Revenue Proposal to AER 2015 - 2018

**Review of Proposed Replacement
Capital Expenditure in TransGrid's
Revised Regulatory Proposal**

**Report to
Australian Energy Regulator
from
Energy Market Consulting associates**

April 2015

Figure 6: Differences in proposed replacement expenditure (\$m, 2014), between RP and RRP

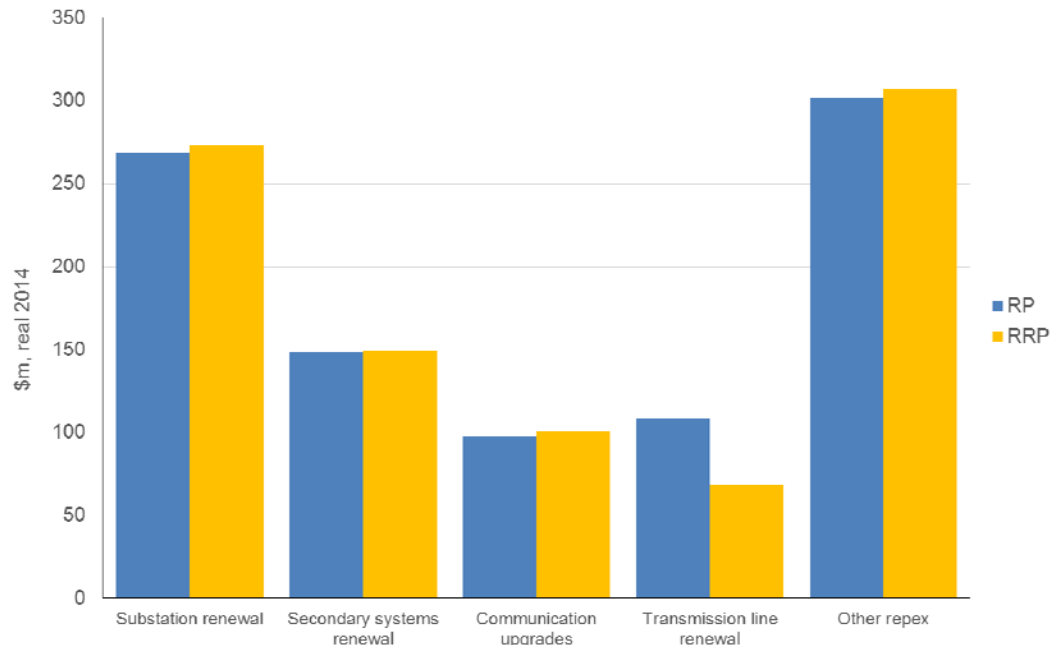
74. We observe that the reduction in the transmission line renewal forecast category is partially offset by modest increases in the other expenditure categories, as shown in Figure 6 and Table 4 below.

75. We note that the transmission lines renewal forecast expenditure has been reduced by \$40.2m. This reduction is partially offset by an aggregate increase of \$13.5m across the other major repex categories, primarily associated with increases in the current year (2015) forecast. TransGrid did not provide a rationale for these increases. The overall impact is a \$26.6m reduction in total replacement capex over the RCP.
